SUBJECT: NEW VEHICLE DEMONSTRATION / DELIVERY HOLD

Customer Satisfaction Program 17B03

Certain 2017 Model Year F-Super Duty Vehicles Equipped with a 6.7L Diesel Engine
Transmission Fluid Cooler Tubes Repair

FIGURE 1

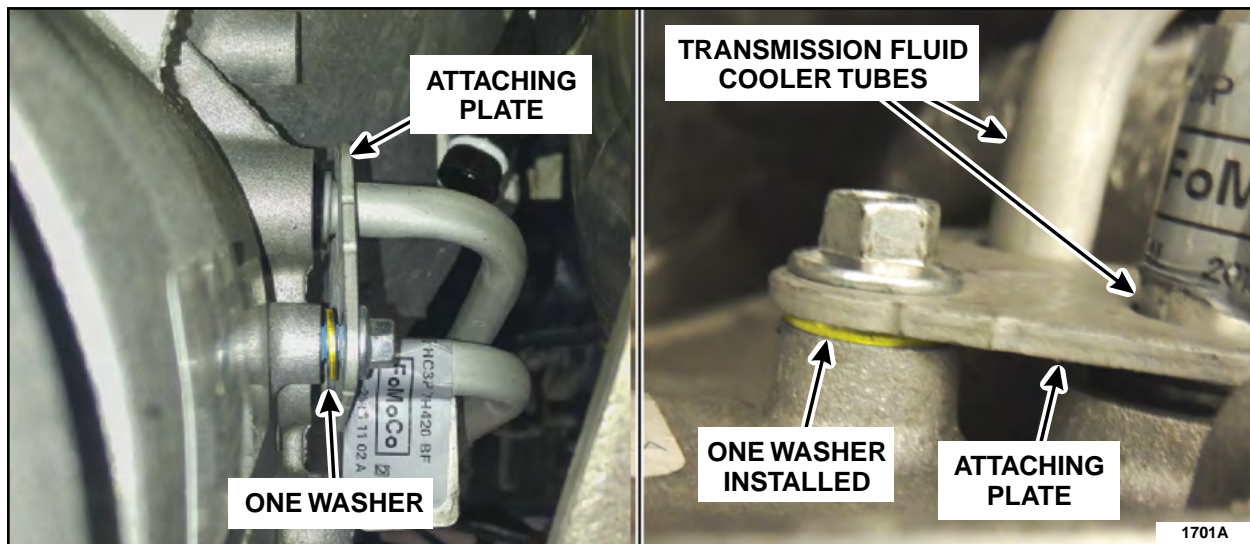
1. Inspect for the presence of a transmission fluid leak from the TFC tubes at the transmission.
 - If a transmission fluid leak **is** detected, proceed to Step 2.
 - If a transmission fluid leak **is not** detected, proceed to Step 3.
2. Replace the TFC tubes. Please follow the Workshop Manual (WSM) procedures in Section 307-02.
 - During installation, install a *new* washer between the transmission case and the TFC tubes attaching plate. See Figure 1.
3. Install a *new* washer behind the TFC tubes attaching plate.
 - a. Remove and discard the TFC tubes-to-transmission bolt.
 - b. Install a *new* washer between the transmission case and the TFC tubes attaching plate. See Figure 1.
 - c. Install the *new* bolt and tighten to 18 lb.ft (25 Nm).
